REV.	BY	DATE	DESCRIPTION
3	LBB	5/26/09	REVISED - ELIMINATED DETAILS

PROJECT NAME:	SPRINGFIELD
PROJECT NUMBER:	BHF 016-2(14)
FILE NAME:	s06j004sup.dgn
PROJECT LEADER:	R. WHITCOMB
DESIGNED BY:	C. CARLSON
BEARING ELEVATIONS AND NOTES	
PLOT DATE:	29-MAY-2009
DRAWN BY:	C. MOONEY
CHECKED BY:	D. PETERSON
SHEET	34 OF 72

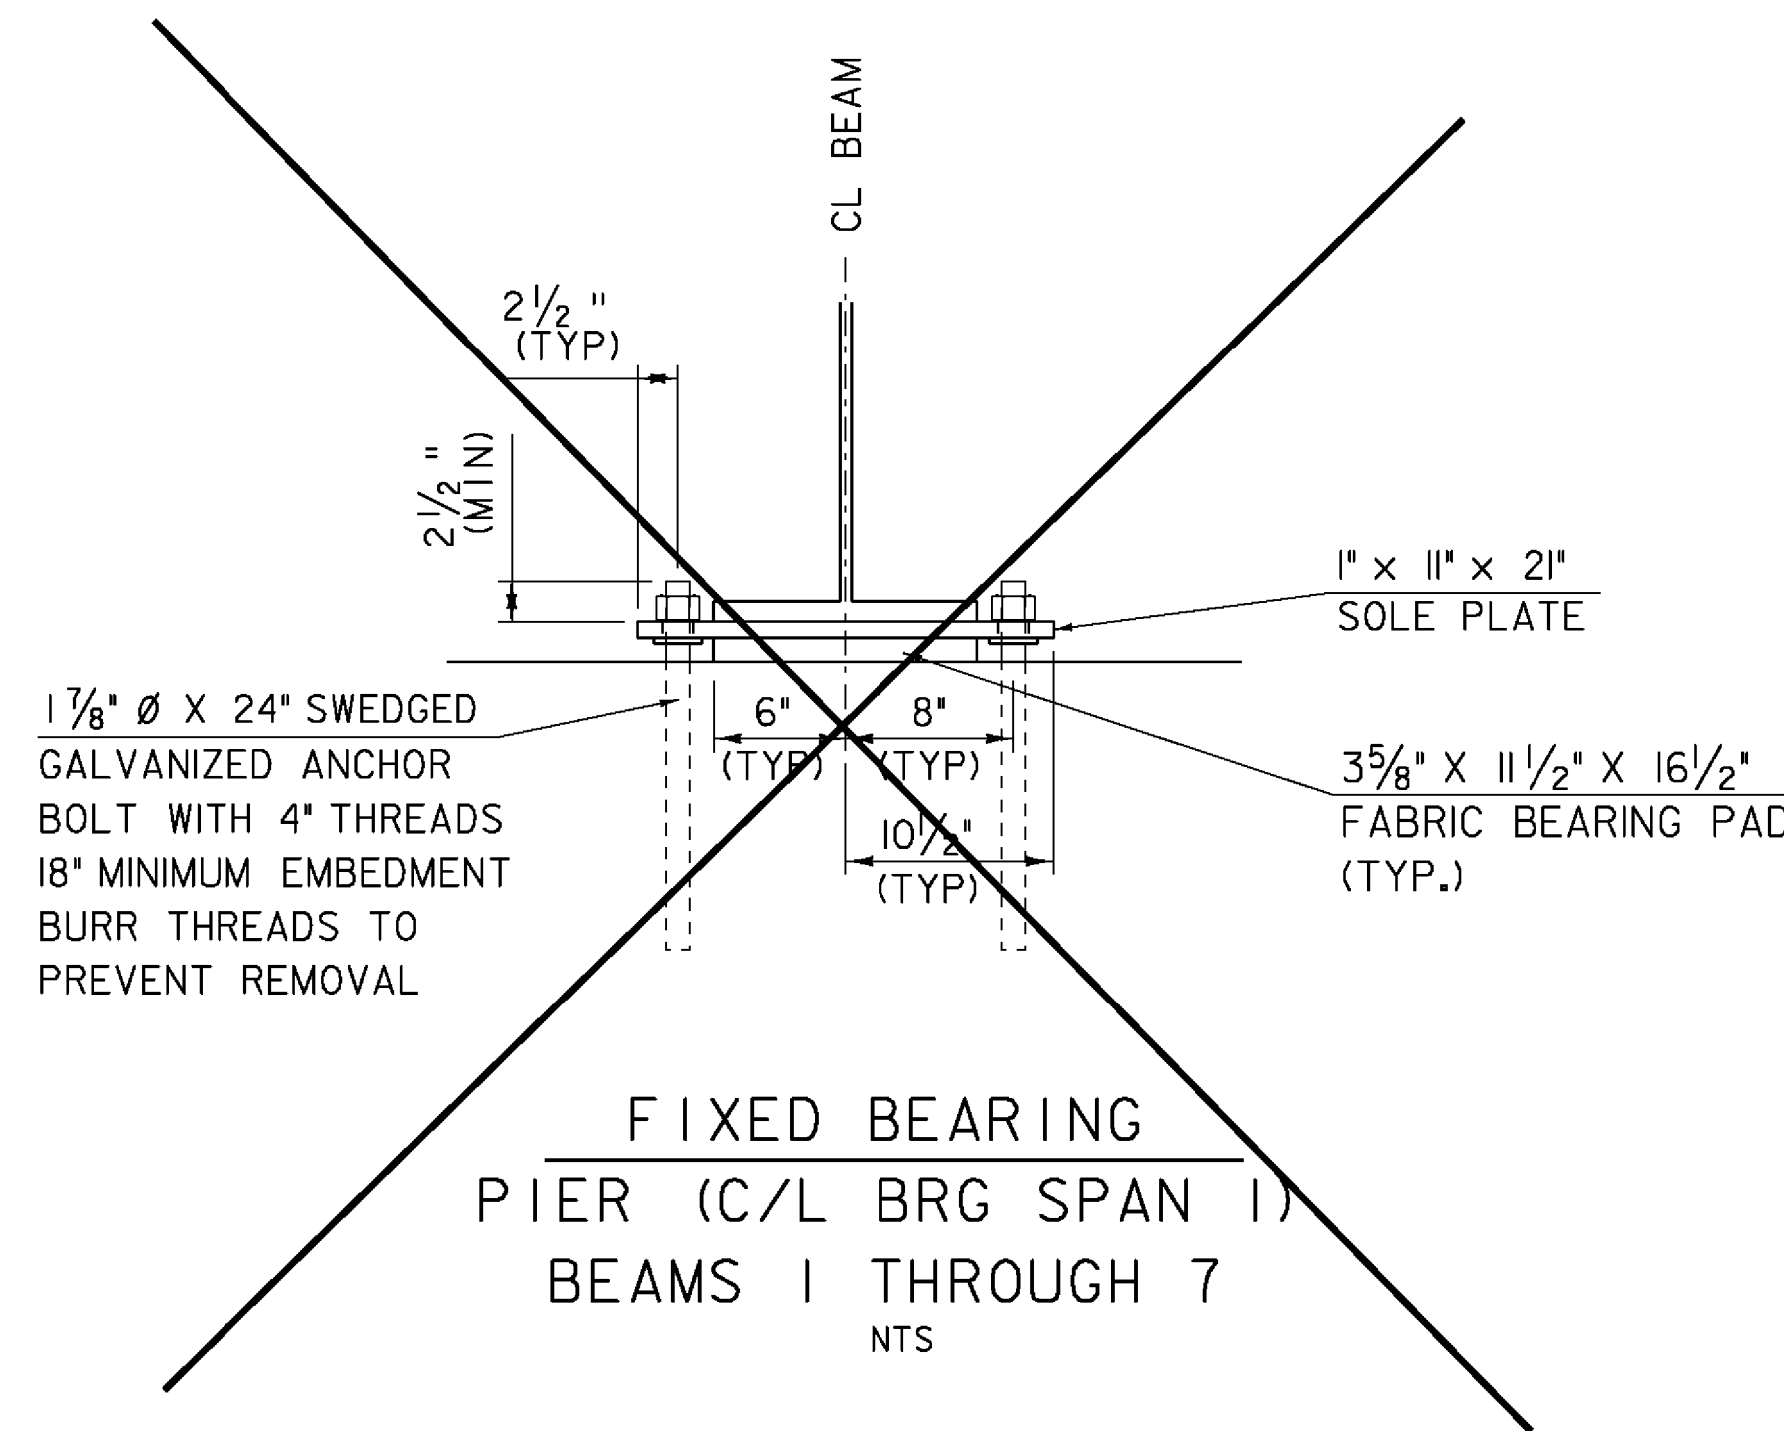
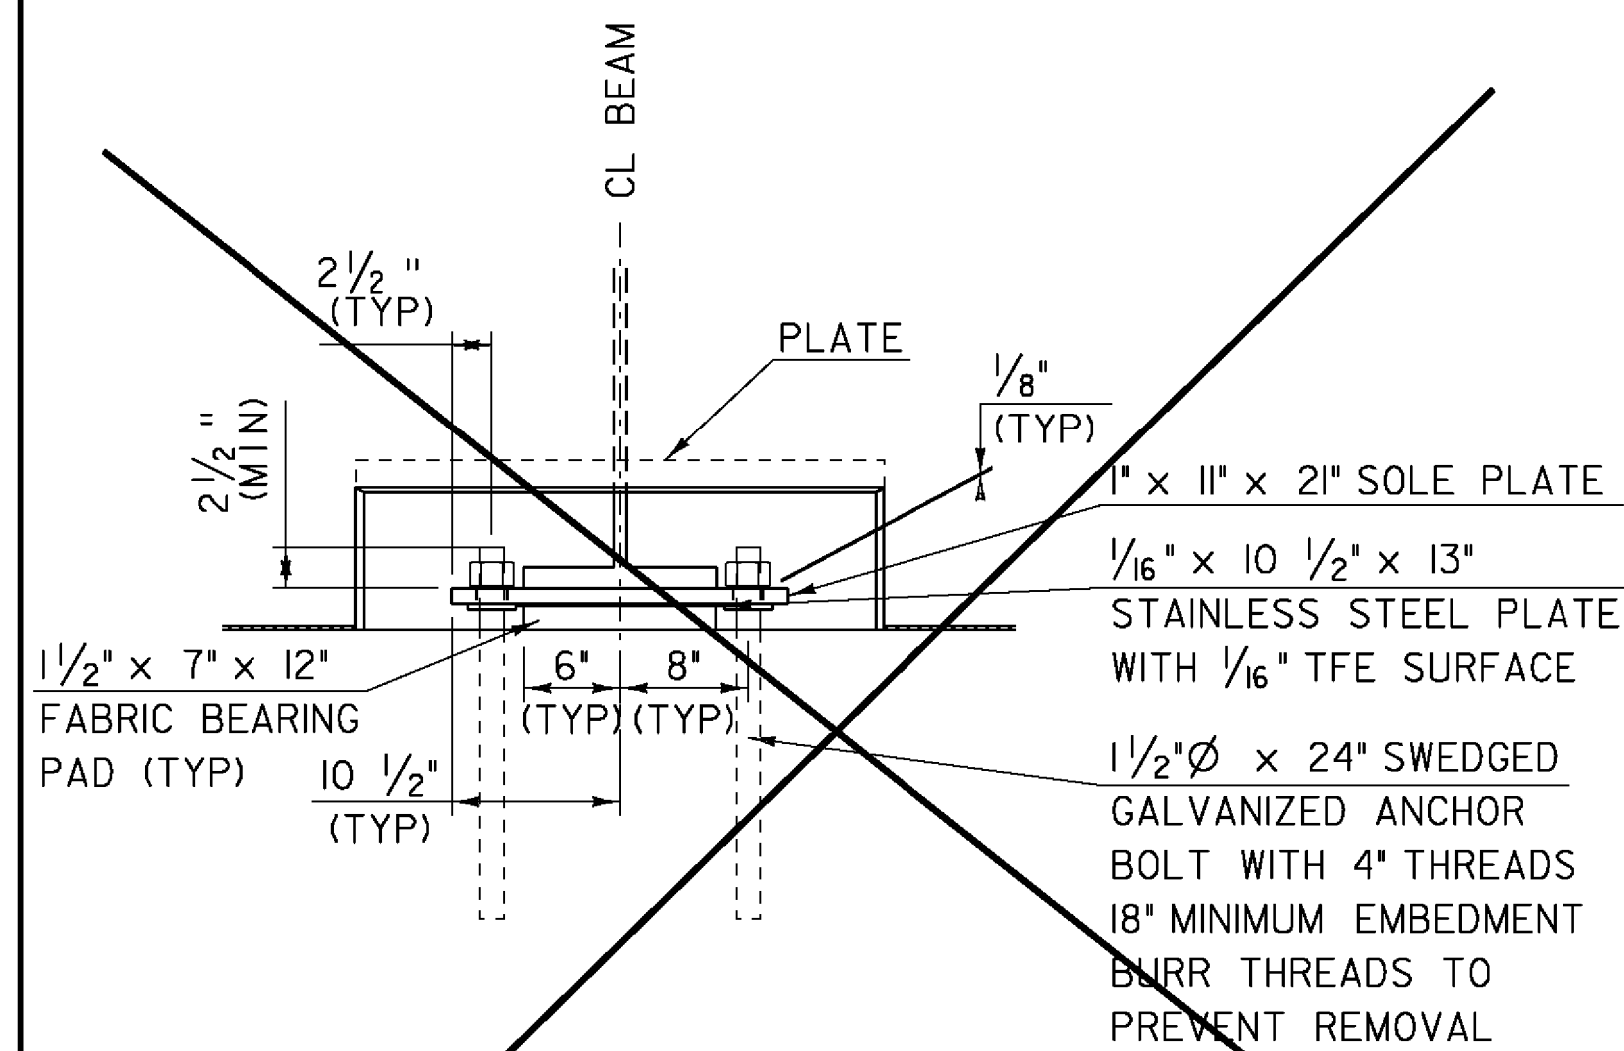
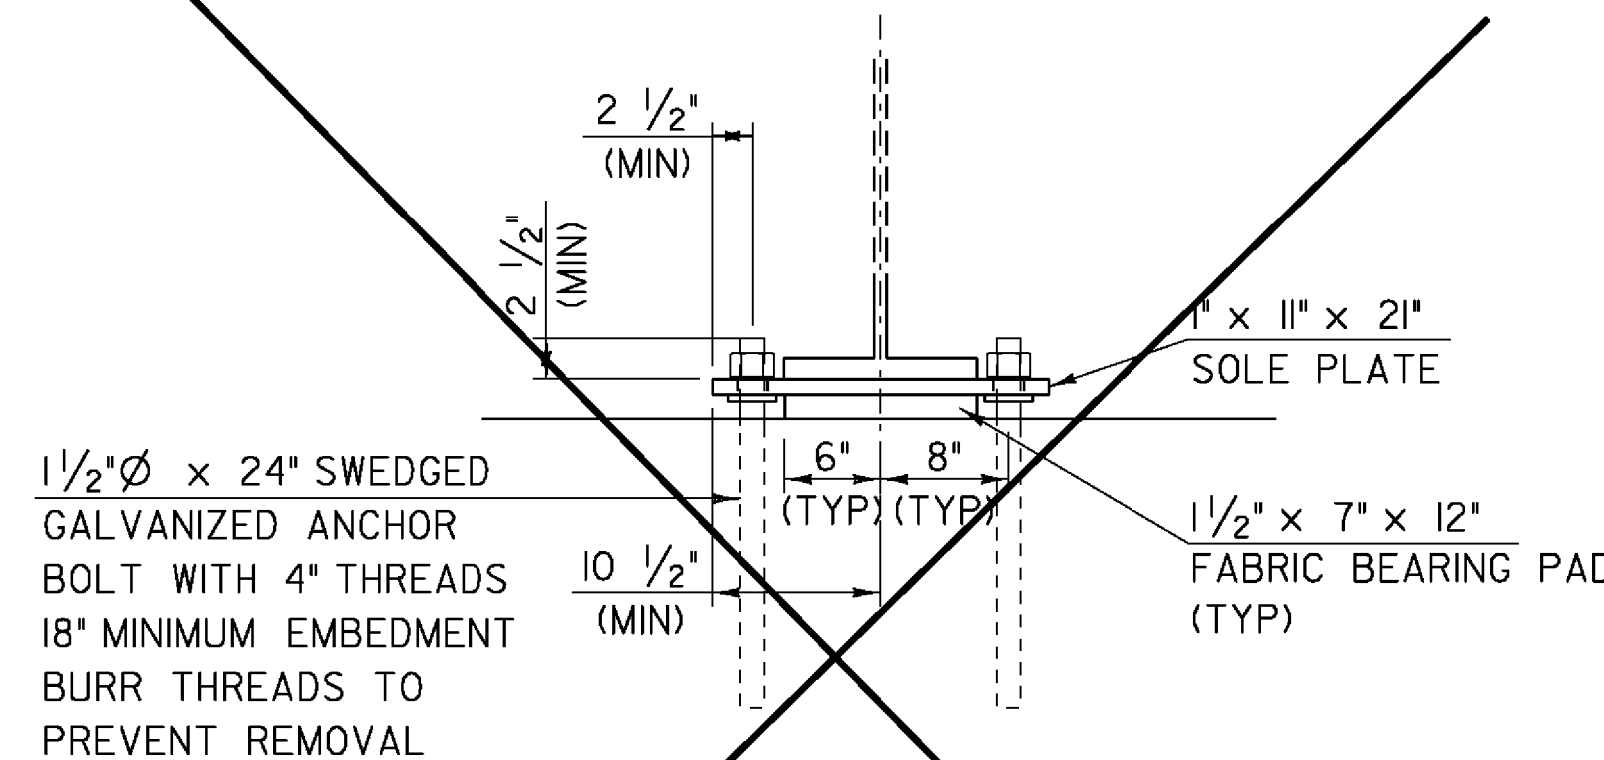
- ~~ALL JACKING AND SHORING REQUIRED TO REPLACE BEARINGS WILL BE PAID FOR UNDER ITEM 502.11, "SHORING SUPERSTRUCTURE BEARINGS". THE CONTRACTOR SHALL SUBMIT DETAILS AND CALCULATIONS FOR SHORING AND JACKING AS SPECIFIED IN SECTION 502.~~

- ~~EXISTING HOLES IN THE EXISTING BEAM FLANGES SHALL BE CLEANED AND FILLED WITH JOINT SEALER, POLYURETHANE AS SPECIFIED IN SUBSECTION 707.05. THIS WORK SHALL BE INCIDENTAL TO ITEM 531.10, "BEARING DEVICE ASSEMBLY, PREFORMED FABRIC PAD".~~
